## IMPORTANT SAFETY RECALL

Triple E Recreational Vehicles Recall CA#7842-1

This notice is sent to you in accordance with the requirements of the National Traffic & Motor Vehicle Safety Act. Triple E Recreational Vehicles has decided that certain 2014 Libero and Serenity Motorhomes manufactured between September 2013 & March 2014 fail to conform to Federal Motor Vehicle Safety Standard No. 108, “Lamps, Reflective Devices, and Associated Equipment

**Replacing Rear Tail Light Bulbs (QAAR 7842)**

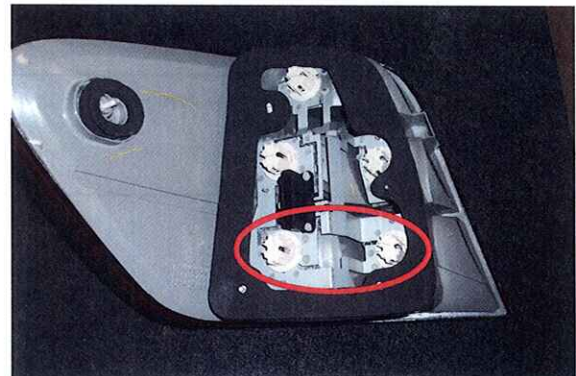
- 3) Remove the 4 nuts from each light.

- 4) Remove the lights from the rear mask.
- 5) Remove the 2 lower bulb holders and replace the bulbs with:
  - Libero - 21watt bulbs (127-4517)
  - Serenity - LED bulbs (127-4519)

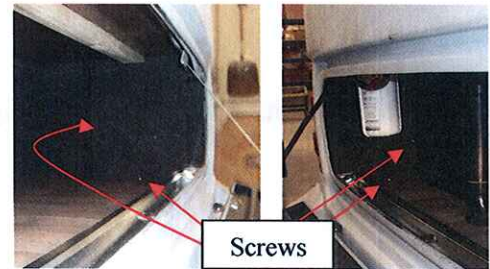
- 6) Reinstall lights into the rear mask.
- 7) Reinstall the 4 nuts from each light back onto the lights. (firmly push the lights into the pocket when installing the nuts)
